**NOTICE OF TECHNICAL MODIFICATIONS
TO DEVELOPMENT AGREEMENT
FOR THE SILVER CREEK VILLAGE SPECIALLY PLANNED AREA**

SNYDERVILLE BASIN, SUMMIT COUNTY, UTAH

**EXHIBIT B1
TO NOTICE OF TECHNICAL MODIFICATIONS TO DEVELOPMENT AGREEMENT
FOR THE SILVER CREEK VILLAGE SPECIALLY PLANNED AREA**

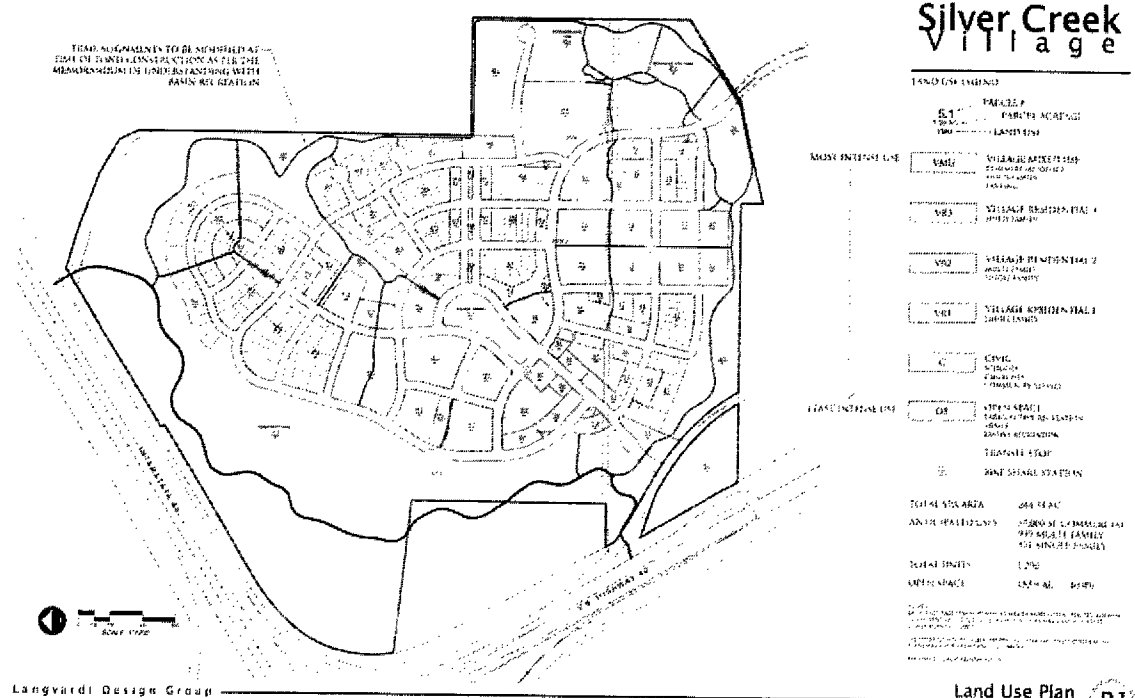
2. Technical Modifications to Blocks 5, 9 and 12. The County, by way of a Technical Modification to the DA, has approved the modification of the configuration, size, or numbering of certain Parcels within Blocks 5, 9 and 12 and the Land Use Plan, required due to the County Engineer’s requirement of relocating the Village Main Street (also known as Old Forest Drive). Parcels within Blocks 5 and 9 have been combined into one Block 5 (thereby eliminating Block 9), the Block 5 Parcels have been reconfigured accordingly, and the configuration of certain Parcels within Block 12 has been modified accordingly. The reconfigured Parcel details are summarized as follows:

Parcel	Size	Land Use
5.1	0.60 AC	VMU
5.3	0.41 AC	VR1
5.4	1.32 AC	VMU
5.5	0.42 AC	VR2
5.6	0.24 AC	VMU
5.7	0.41 AC	VMU
12.2	0.32 AC	VMU
12.3	0.78 AC	VMU
12.4	0.65 AC	VR3
12.5	1.82 AC	VMU

There has been no change of use of such Parcels as a result of such Technical Modification. A copy of the updated Land Use Plan is attached to this Notice as **Exhibit B1**. The Parties intend that this Notice, in part, provide notice of such Technical Modification described in this Section 2.
